BFX_UA300

LED driver IC design change proposal

AW21024/AW21036 LED driver IC

Current design

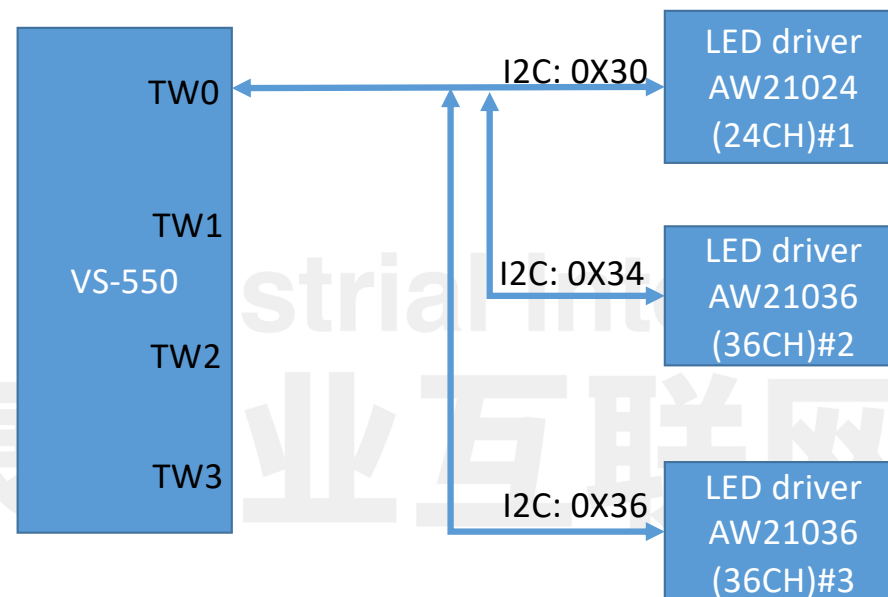
- I2C port of AW21024/AW21024 will use the same as original design on TW0 bus for LED driver.
- Will propose *1pcs AW21024 (24ch) and *2pcs AW21036(36ch) to replace *2 LP5036 (36ch) + *1 LP5024 (24ch) design.
